Re: Water Use License 1BR-DYE0409

UMA Engineering Ltd. is submitting the following proposed modifications as per Section H.1 of the existing license. The notification of modifications is being submitted on behalf of Defence Construction Canada and the Department of National Defence.

The following modifications are being proposed as part of the clean up of the DYE-M, Cape Dyer DEW Line site.

SUBJECT - SUJET
AIR TERMINAL BUILDING
PLAN, SECTION AND ELEVATION

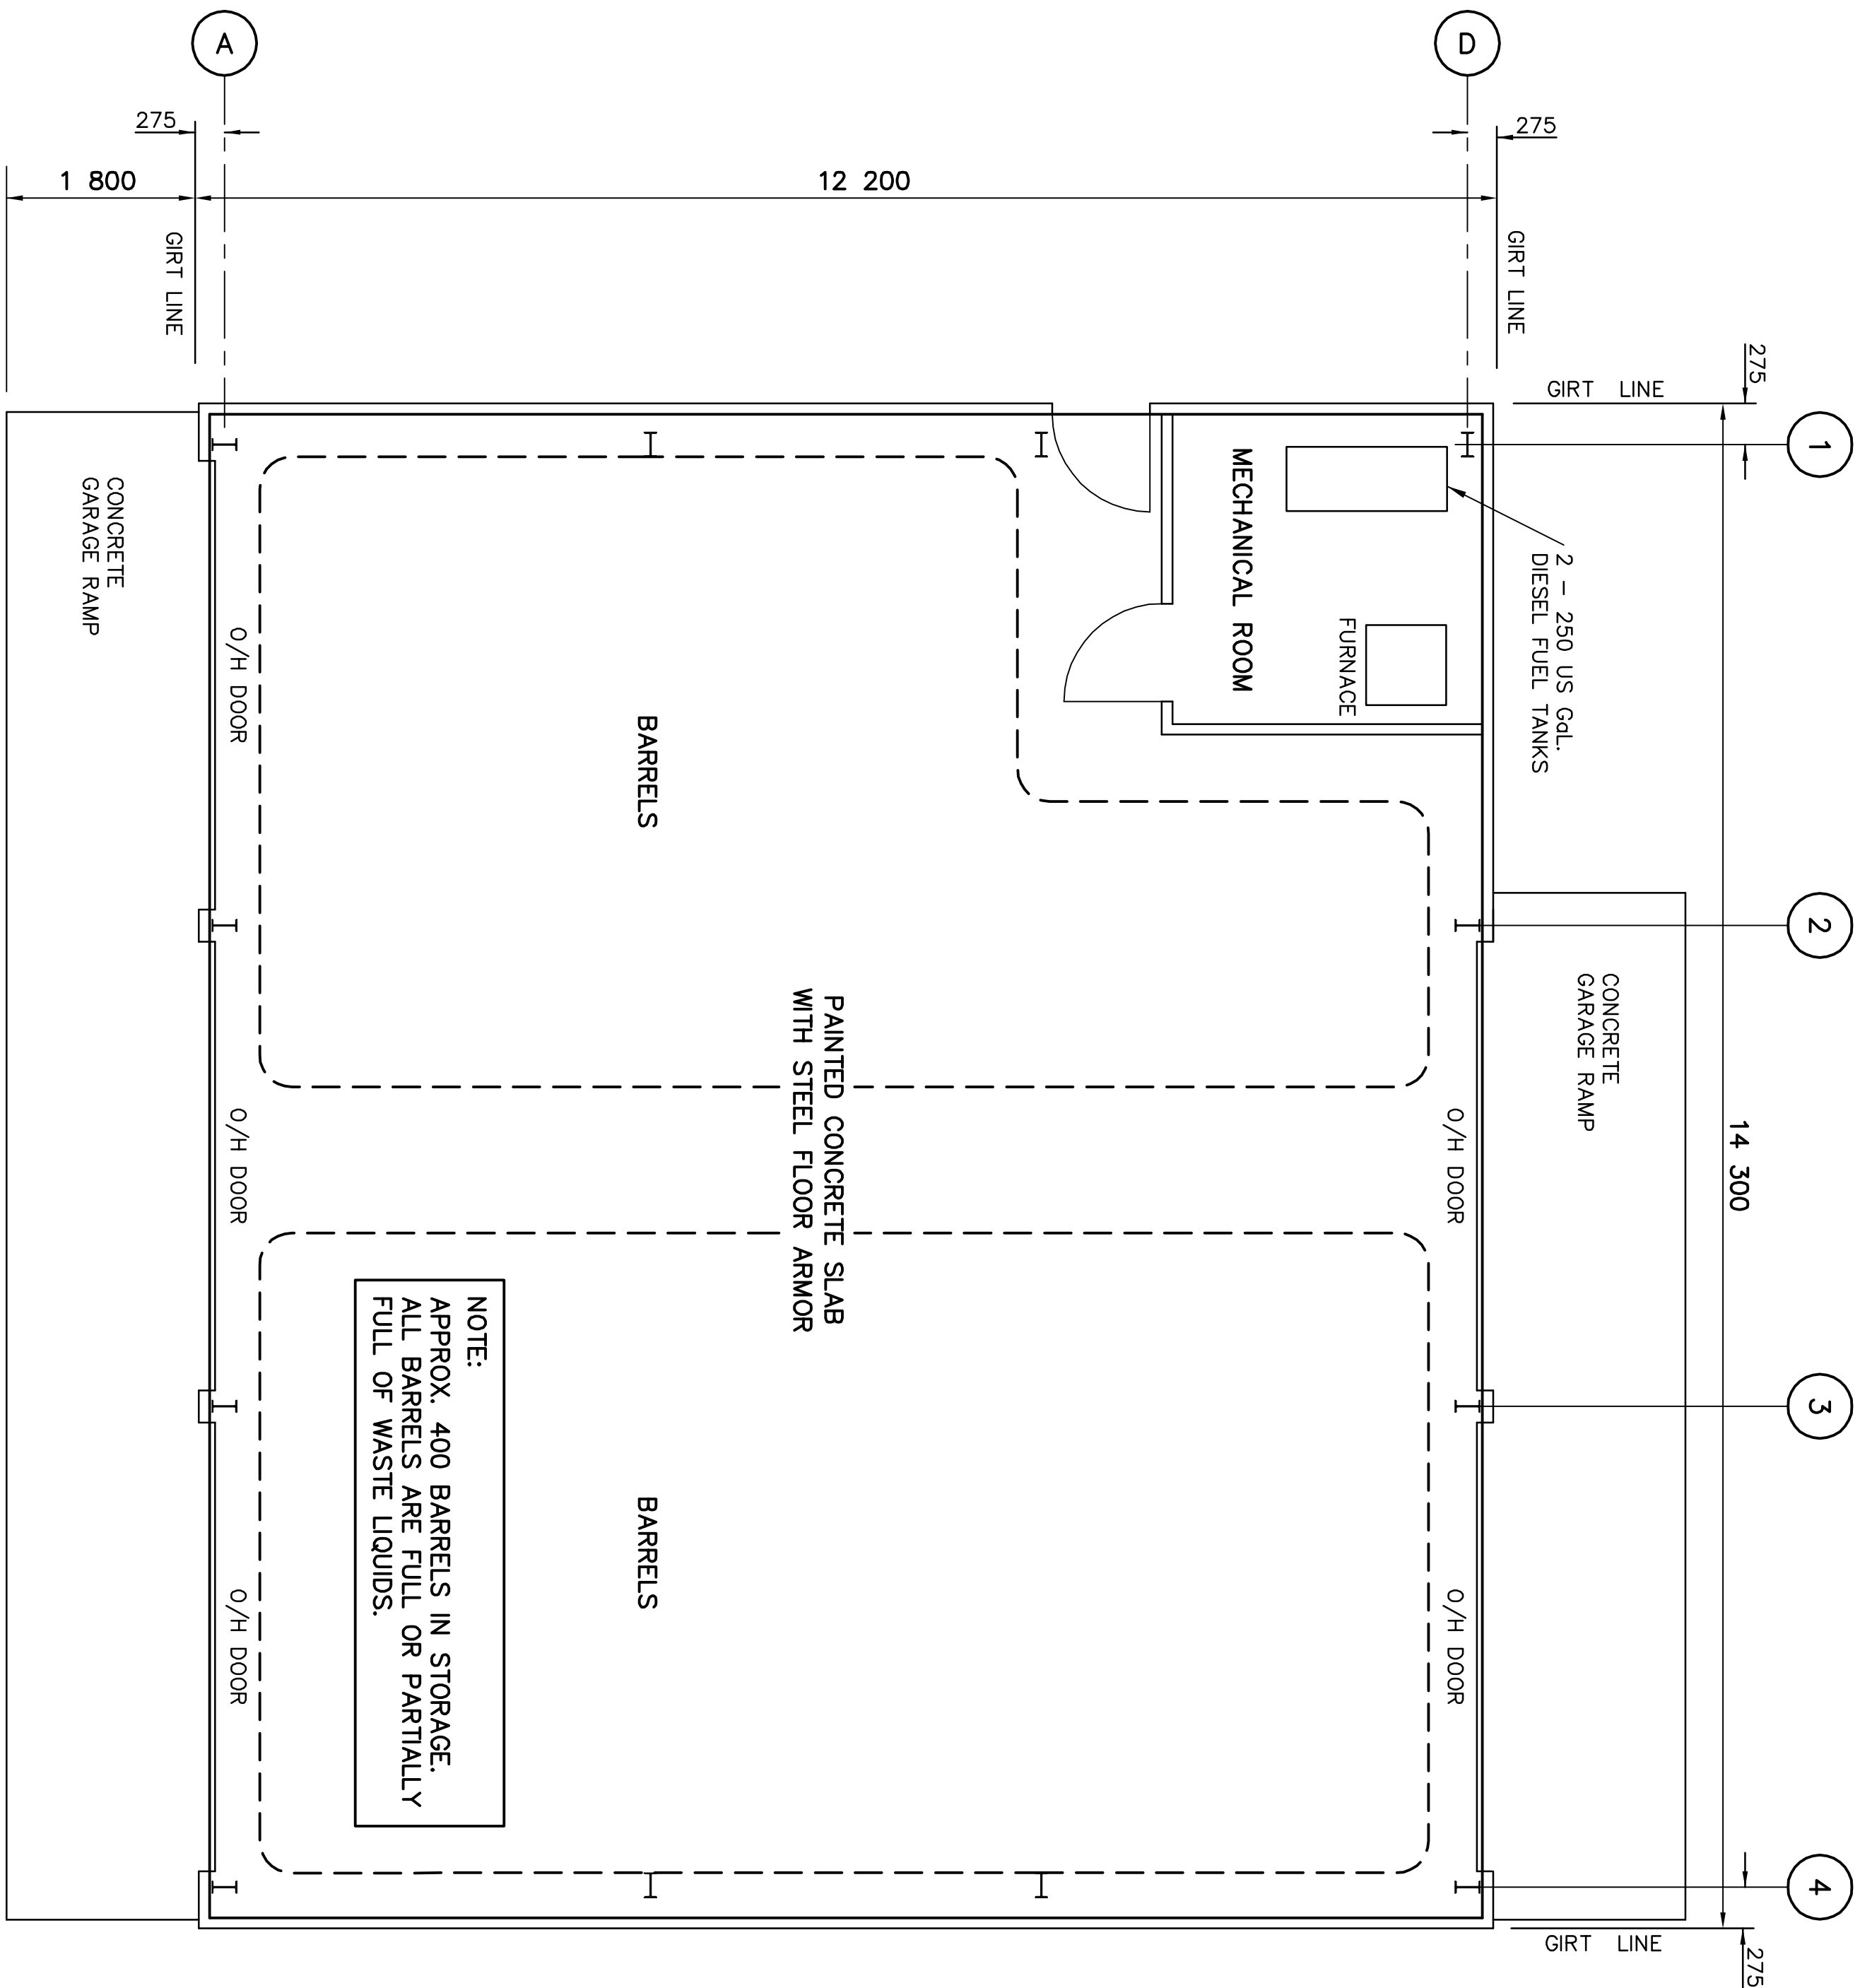
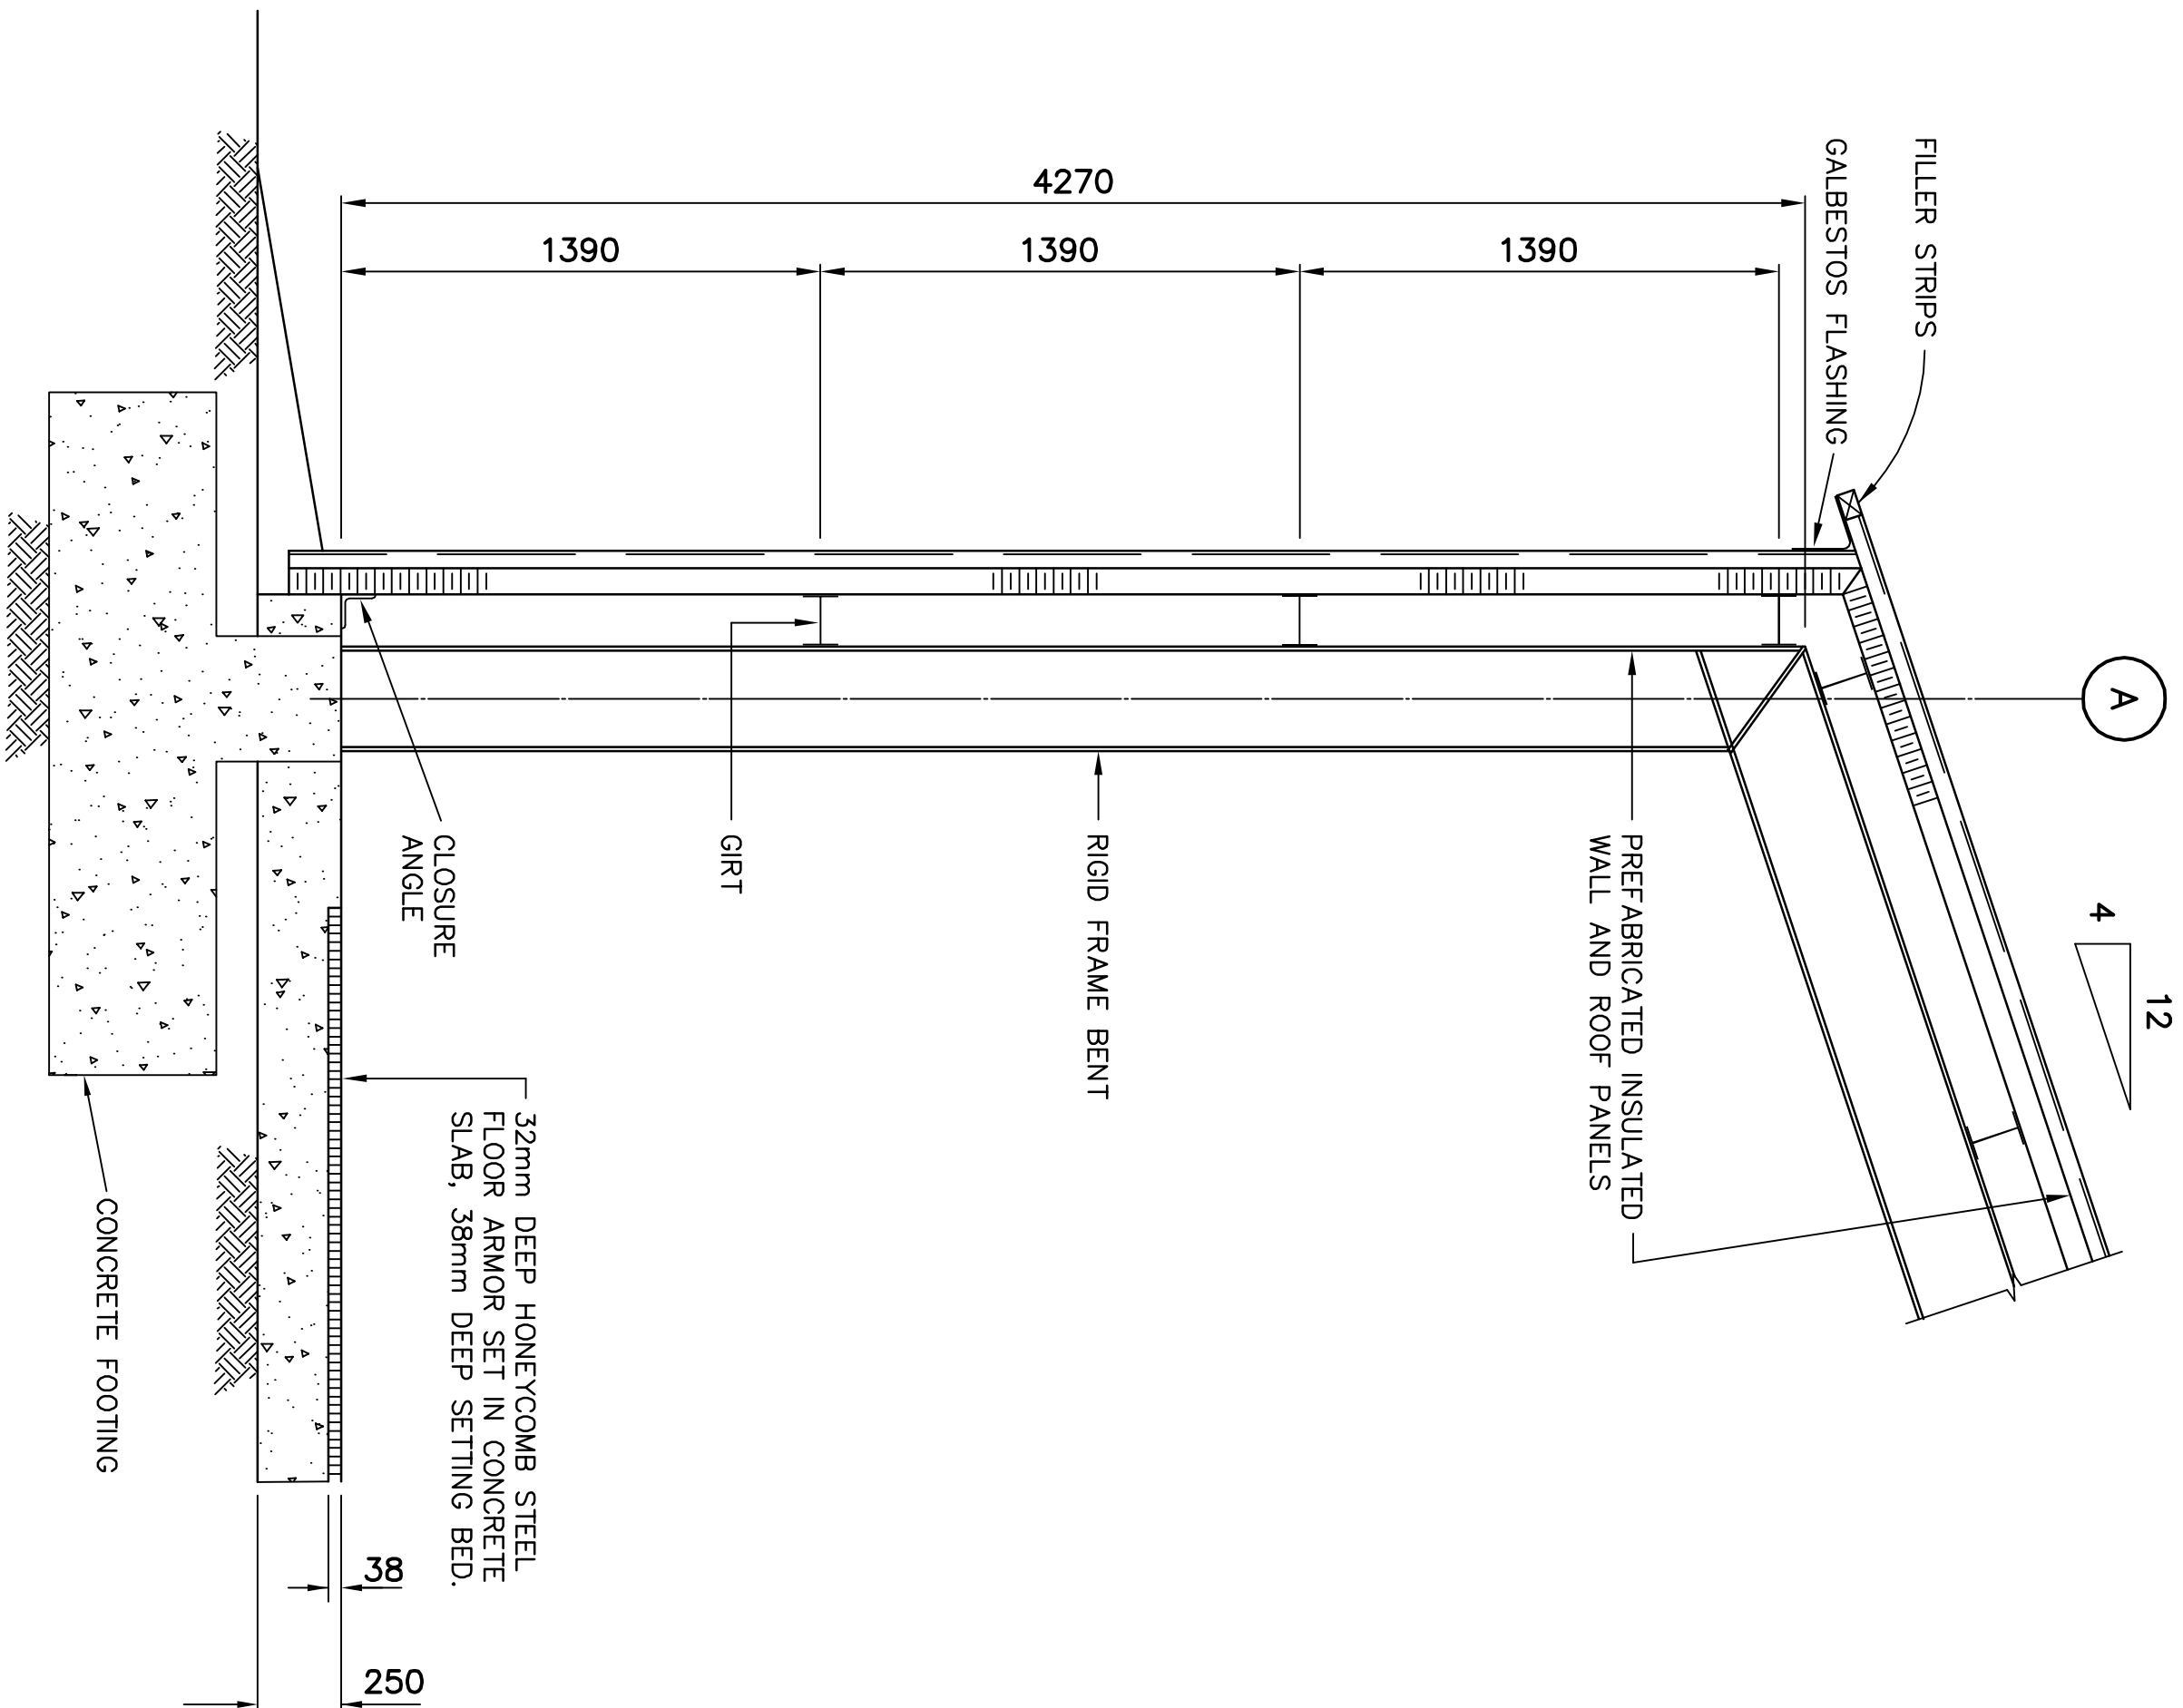
- 2.) Nine additional buildings at the Lower Site are to be demolished, including the air terminal building, four warehouses, two atwell dormitories, the heated vehicle storage building and the garage. However, the demolition of module train C and the walkway from module train B to module train C identified for demolition in the original submission will be cancelled and the buildings will remain.
